PIC16(L)F1508/1509 Family Silicon Errata and Data Sheet Clarification

The following typographic corrections and clarifications are to be noted for the latest version of the device data sheet (DS41609A):

FIGURE 29-3: HFINTOSC FREQUENCY ACCURACY OVER DEVICE V_{DD} AND TEMPERATURE

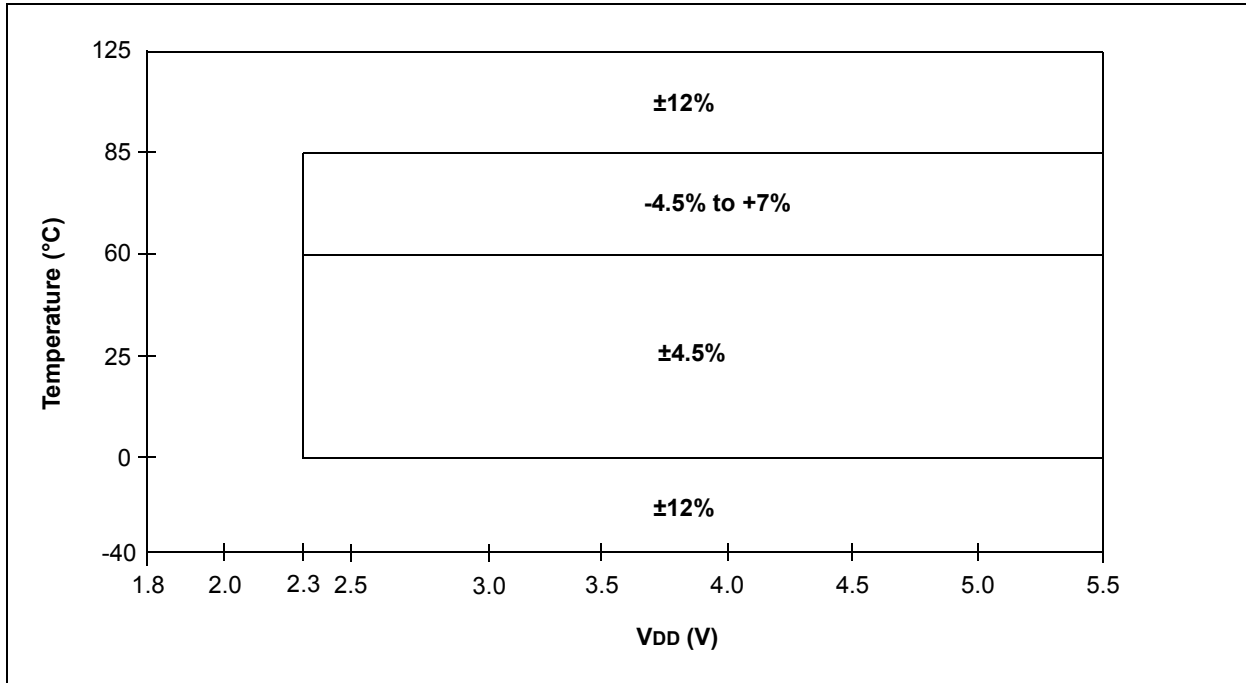
2: See [Figure 29-3](#), HFINTOSC Frequency Accuracy over Device V_{DD} and Temperature, [Figure 30-73](#), HFINTOSC Accuracy Over Temperature, $V_{DD} = 1.8\text{V}$, PIC16LF1508/9 Only, and [Figure 30-74](#), HFINTOSC Accuracy Over Temperature, $2.3\text{V} \leq V_{DD} \leq 5.5\text{V}$.

[Figure 29-3](#) and [Figures 30-71](#) through [30-74](#) were added for [Table 29-2](#) reference.

FIGURE 30-71: LFINTOSC FREQUENCY OVER V_{DD} AND TEMPERATURE, PIC16LF1508/1509 ONLY

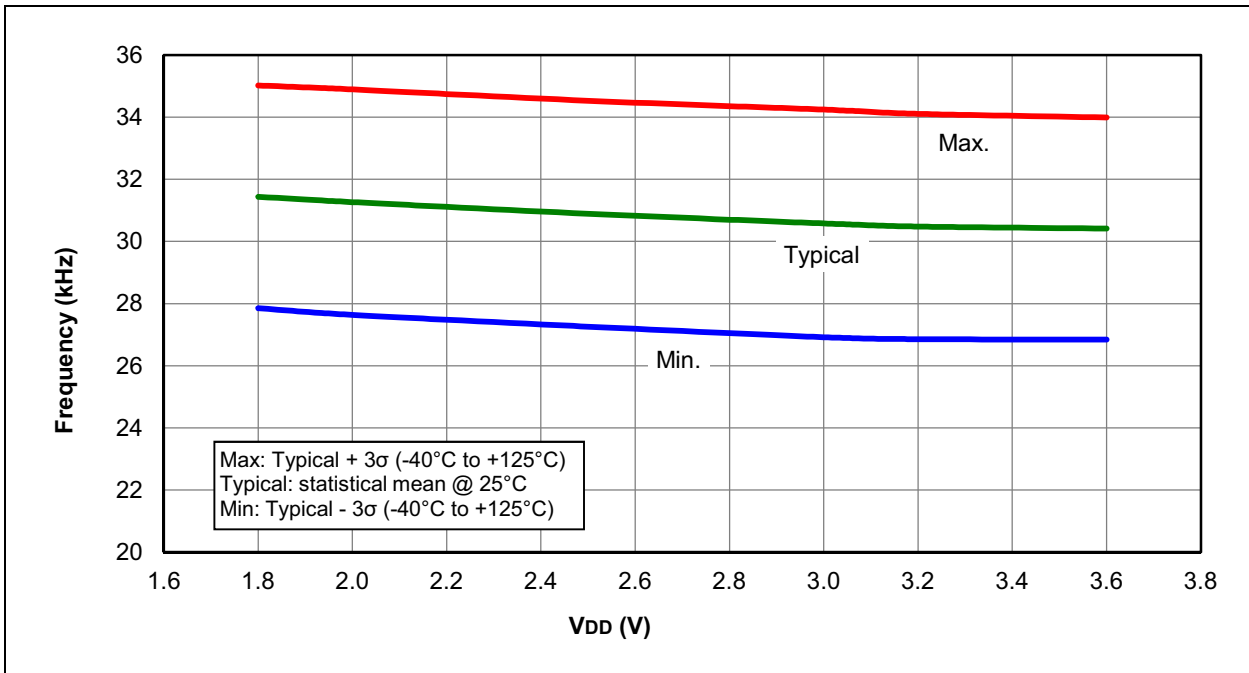
3: See [Figure 30-71](#), LFINTOSC Frequency over V_{DD} and Temperature, PIC16LF1508/9 Only, and [Figure 30-72](#), LFINTOSC Frequency over V_{DD} and Temperature, PIC16F1508/9.
